# Central Nebraska Veterans Home

## Addendum 3

Kearney, Nebraska  
1404

Date Issued: December 8, 2015  
Bid Date: December 17, 2015

PARTIAL SITE POWER PLAN - BLUE PHONE STATIONS

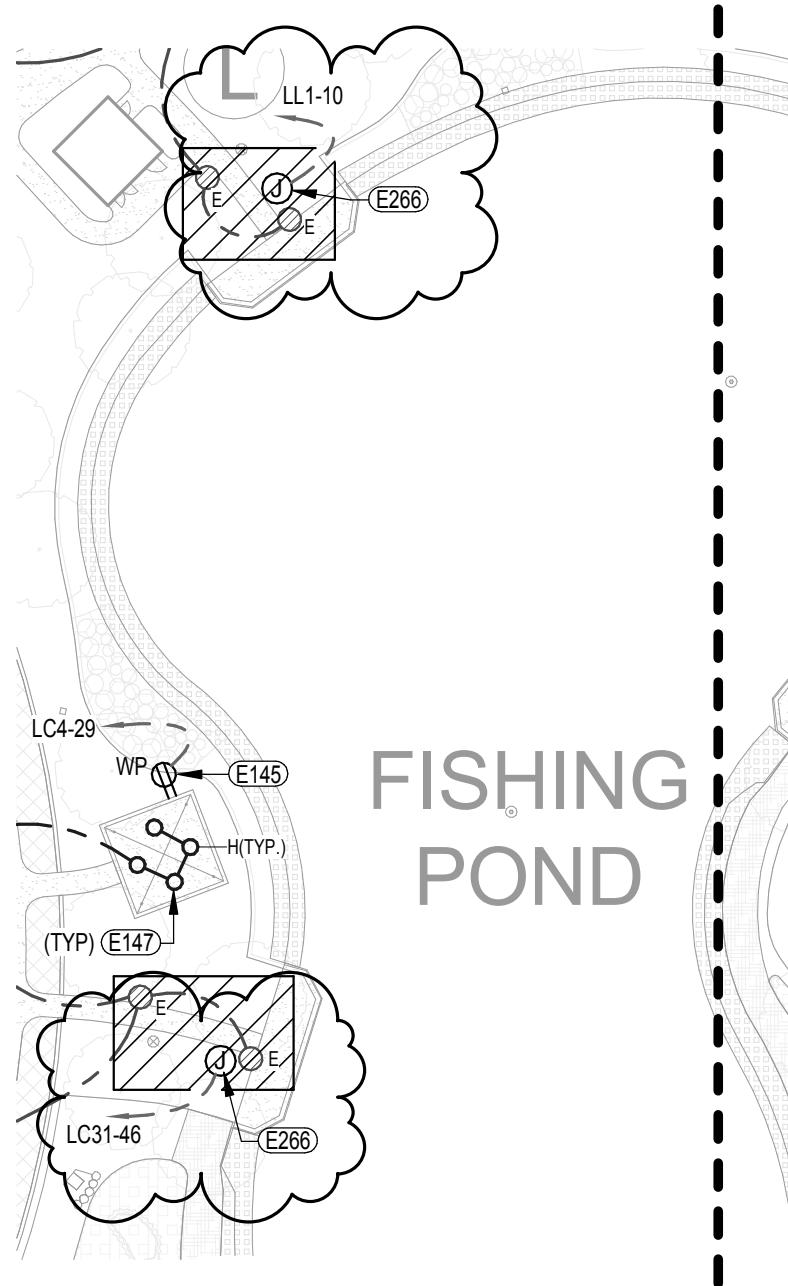
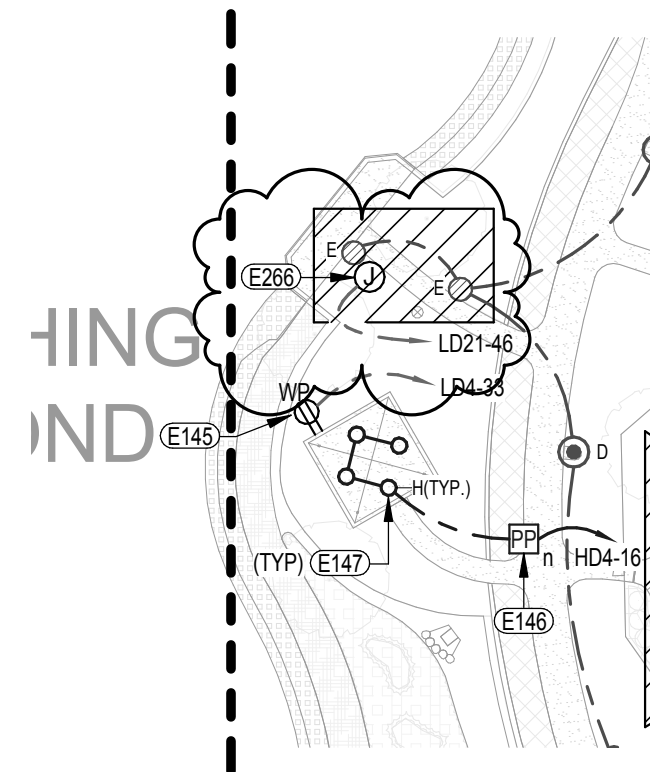
**Sheets E0.01 and E0.02 – Electrical Site Plan**

Provide 120 volt connection to emergency phone pedestals per attached sketch sheet SKE6.

E266 FOR EMERGENCY BLUE PHONE STATION, PROVIDE 2-#10, #10G IN 3/4" CONDUIT FOR CIRCUIT INDICATED. COORDINATE ADDITIONAL REQUIREMENTS WITH EQUIPMENT SUPPLIER.
